# STAFF REPORT

## DMA-22-208, Ordinance No. 2023-06

Development Master Plan Amendment —  
Pattern Book for Development of Towne Center  
(AKA Heron Creek Pattern Book)

<b>PROJECT:</b>	Heron Creek Pattern Book Amendment, DMA-22-208
<b>REQUEST:</b>	Consideration of Development Master Plan Amendment petition amending the Heron Creek Pattern Book
<b>APPLICANT:</b>	Matthew J. Morris, P.E. of Morris Engineering & Consulting, LLC.
<b>OWNERS:</b>	Marsh Creek Holdings, Ltd.
<b>LOCATION:</b>	Activity Center #2
<b>PROPERTY SIZE:</b>	± 160 acres

**HERON CREEK TOWN CENTER MASTER PLAN**  
**HERON CREEK**  
NORTH PORT, FLORIDA

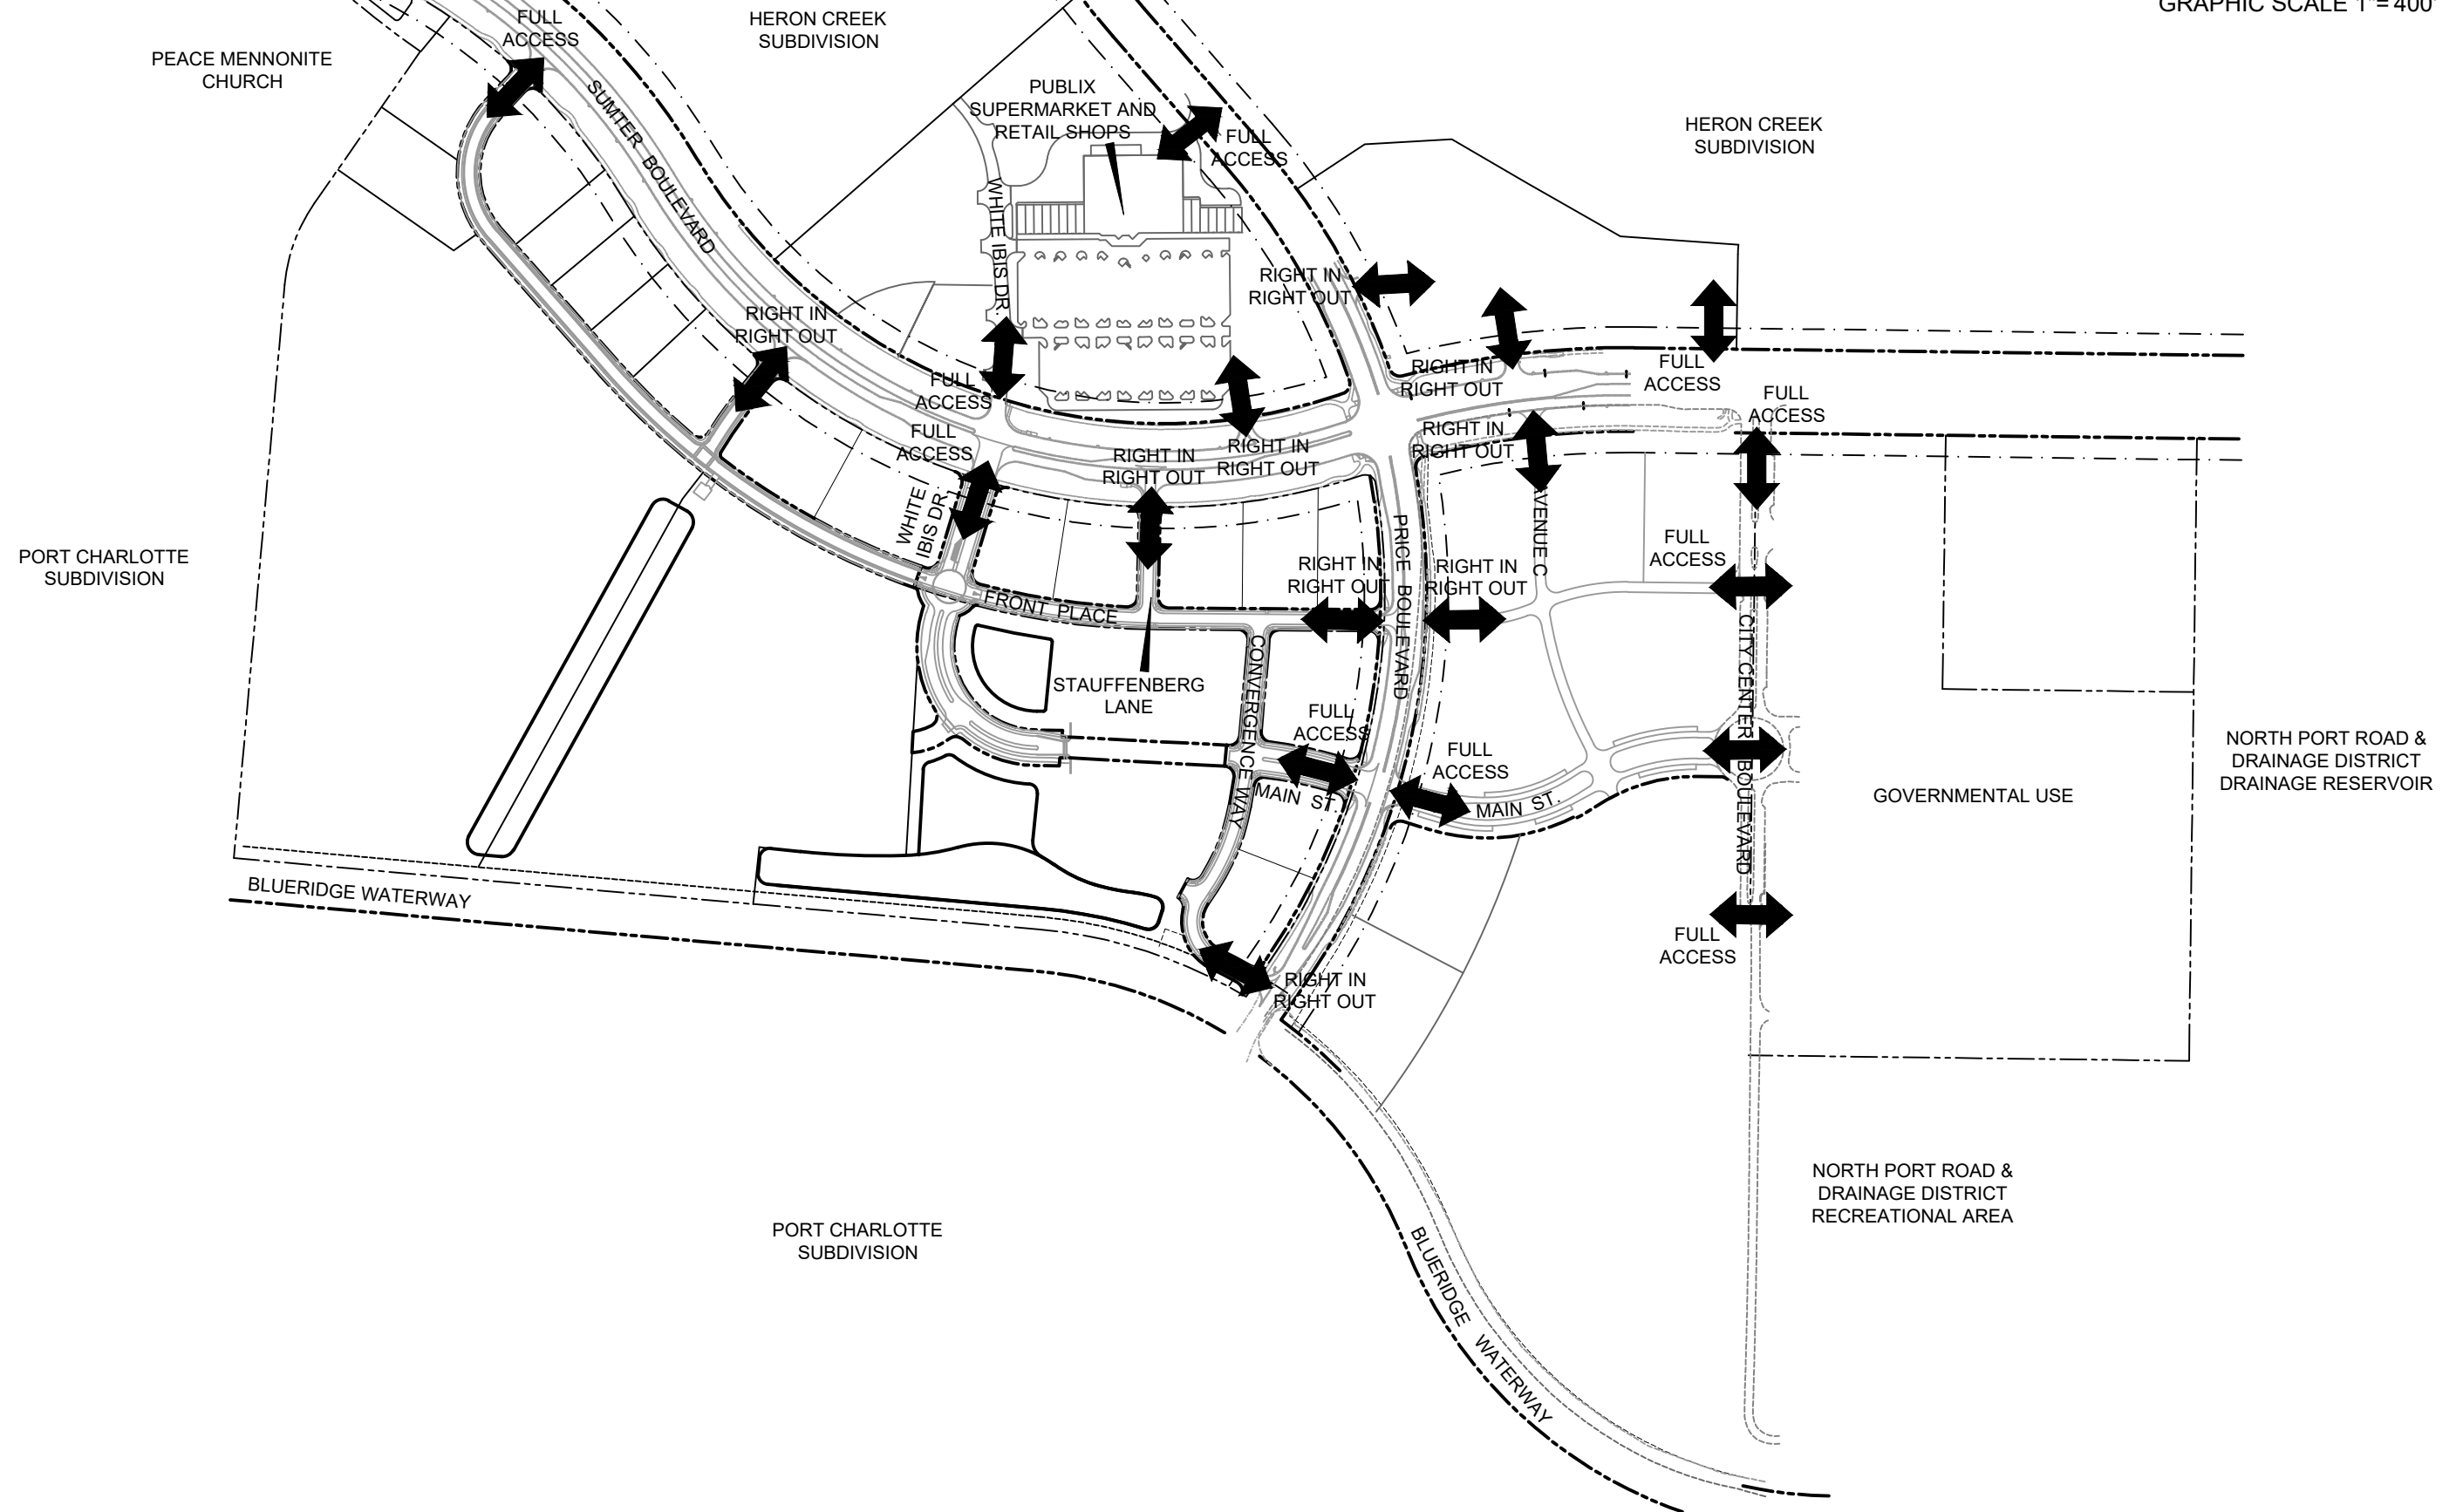
Proposed Amendments (see **Exhibit A**)

- Denote the outparcels between Front Place and Sumter Blvd (including two outparcels south of Front Place) as “General Commercial Use Type 2.

- Shows the realignment of Main Street connecting to White Ibis Drive in the southeast quadrant.

- Shows the continuation of Front Place from Price Blvd to Sumter Blvd.

Staff Response: This designation is consistent with the designation of the outparcels immediately to the north.

Staff Response: Please see the response to Amendment #2 on pages 4-5 of this staff report.

Staff Response: See response to Amendment 2 on pages 4-5.

FIGURE 4.4A  
HERON CREEK TOWNE CENTER  
BIKE PATH AND SIDEWALK MASTER PLAN

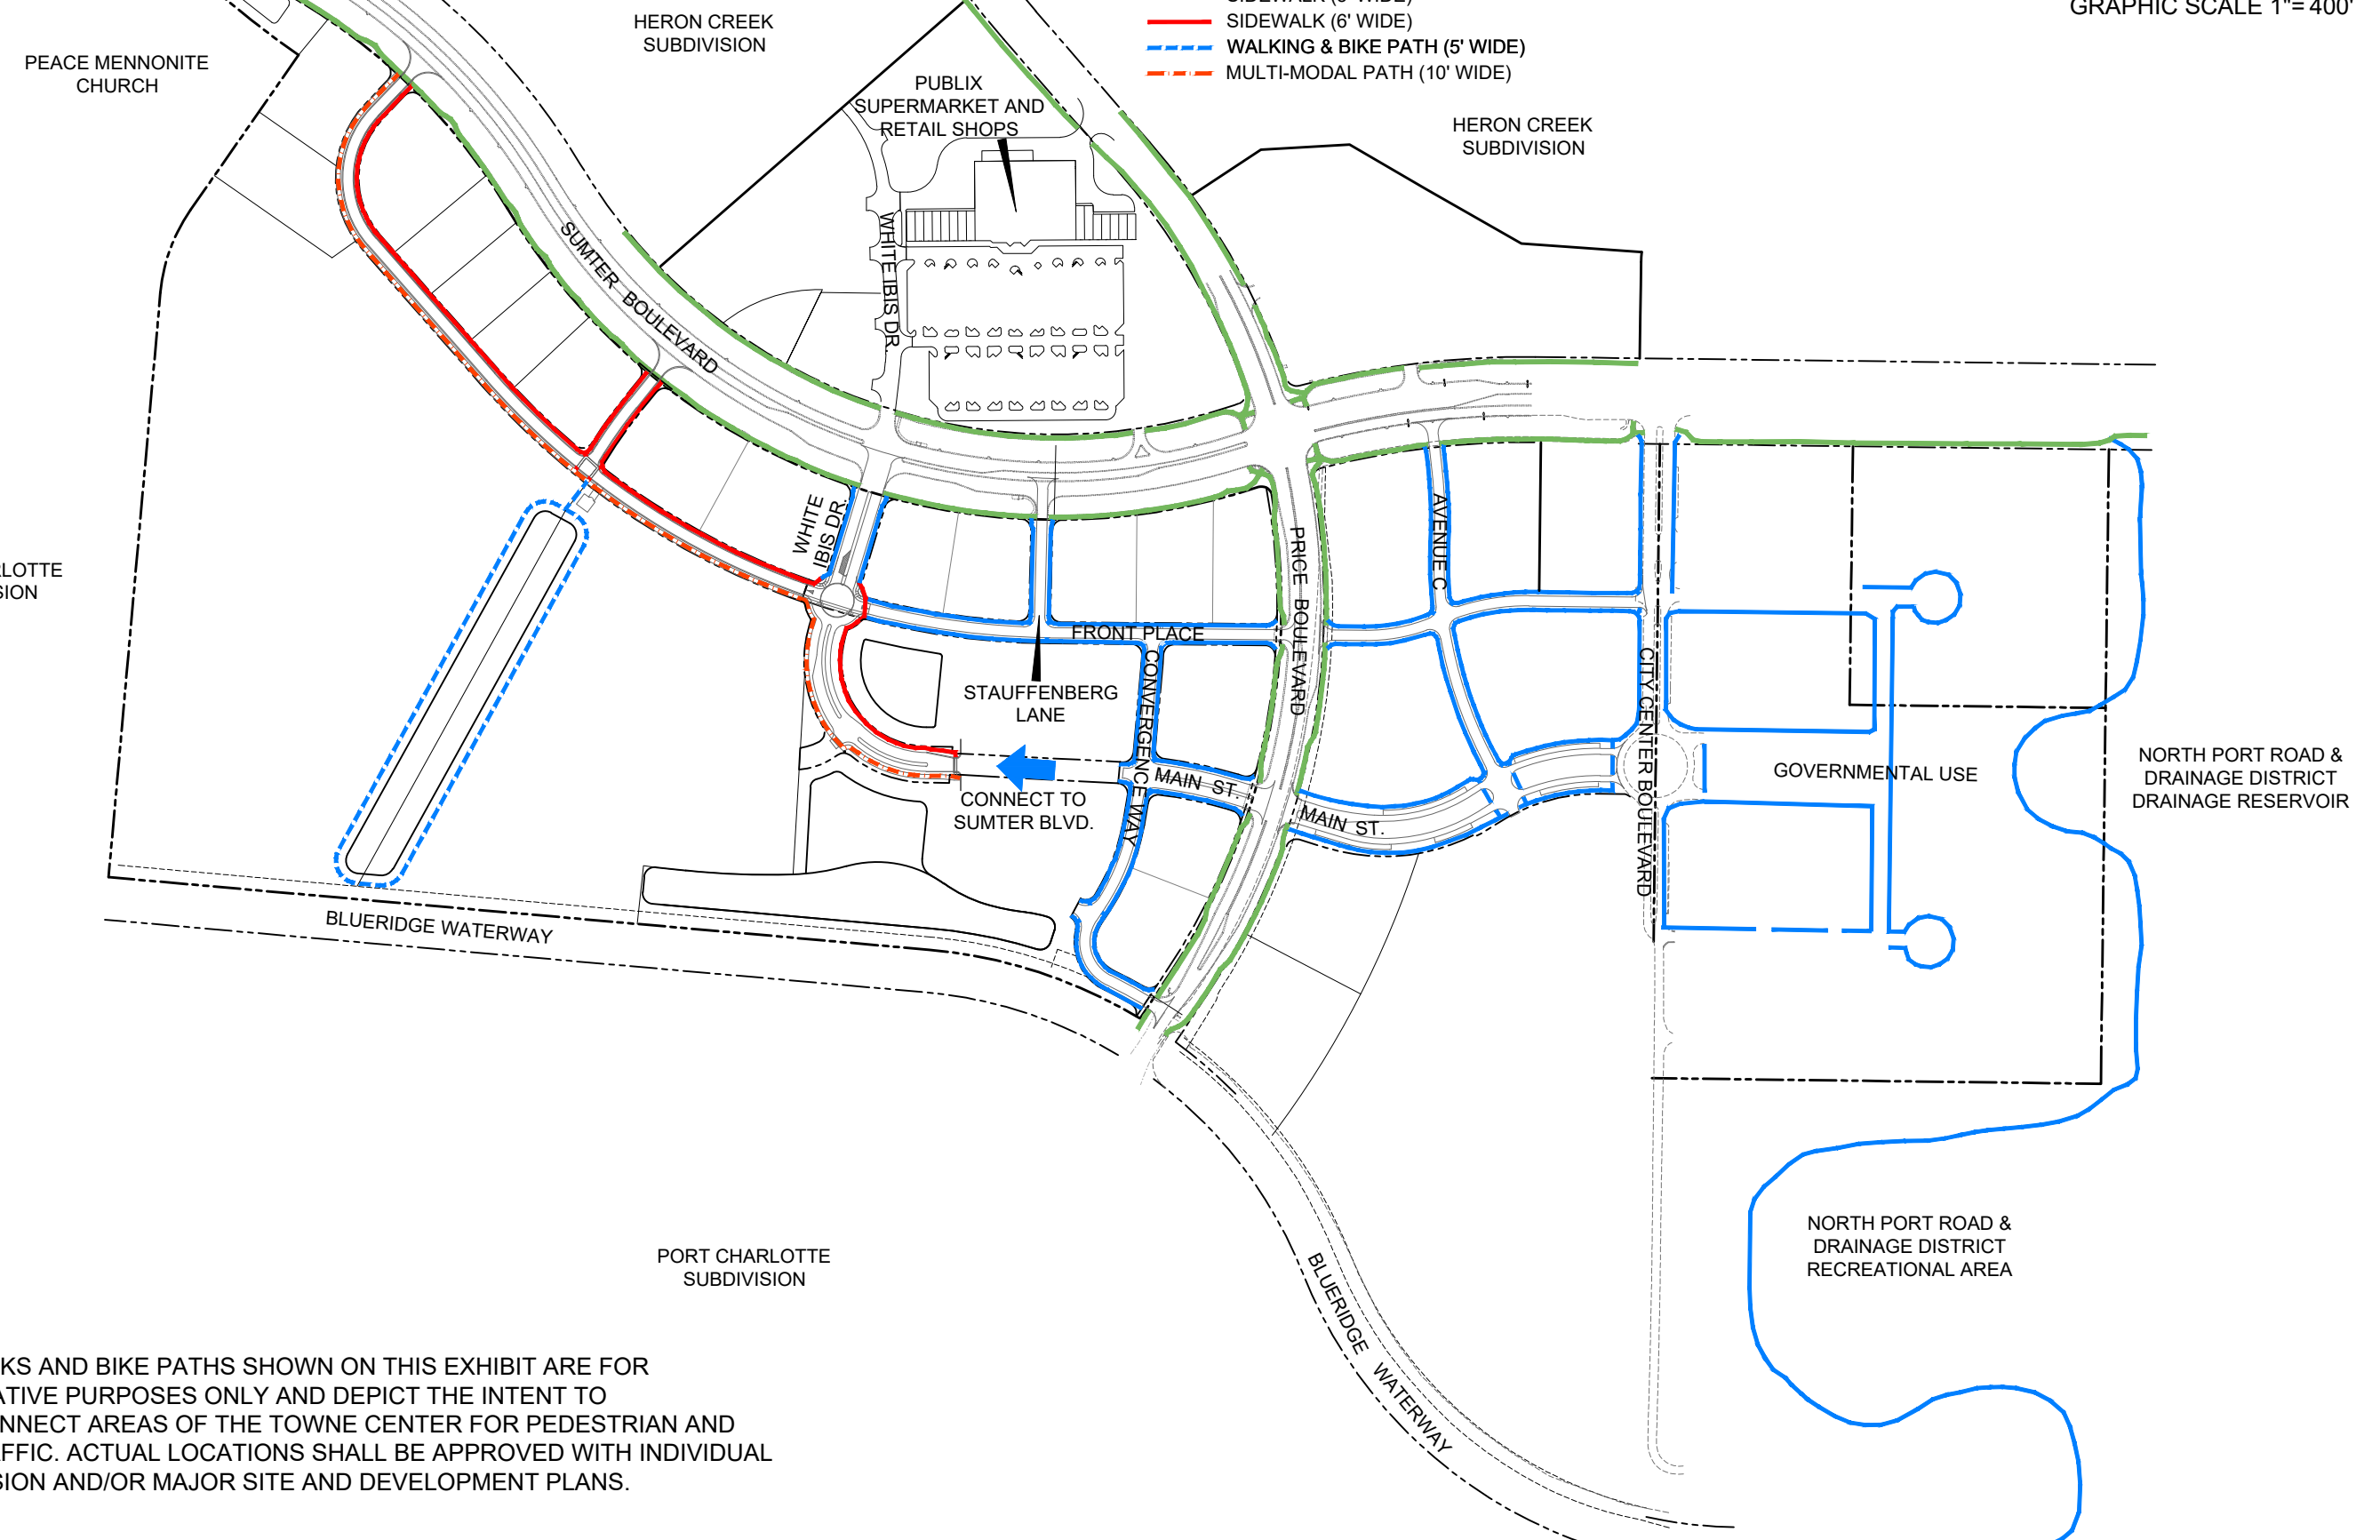
Proposed Amendment: “2.8.1.1 The majority of the system shall be composed of six foot (6’) wide concrete sidewalks in the locations initially depicted on Figure 4.4A. Five foot (5’) wide sidewalk segments over 100 ft that need to be replaced in their entirety shall be replaced with six foot (6’) wide concrete sidewalks. The sense of enclosure shall vary based on the desired scale of the space.”

- On the Bike Path and Sidewalk Master Plan, the bike path along Blue Ridge Waterway and the southern boundary of the southeast quadrant has been relocated to become a multi-modal path running along to the east side of Front Place and White Ibis Drive transitioning into the Walmart Neighborhood Market site. from the Bike Path and

Staff Response: The proposed amendment allows for new sidewalk construction to be at the expanded six (6) foot width and any retrofitted sidewalk segments to the expanded from their current five (5) foot width. The proposed amendment is consistent with the goal to achieve greater walkability and encourage non-motorized means of transportation.

Staff Response: The ten (10) foot multi-modal path proposed provides the connectivity sought by the originally planned bike path and will facilitate bicycle and pedestrian movement between the residential portion of the southeast quadrant, the Walmart Neighborhood Center, the other commercial outparcels, and to both Sumter Blvd and Price Blvd.
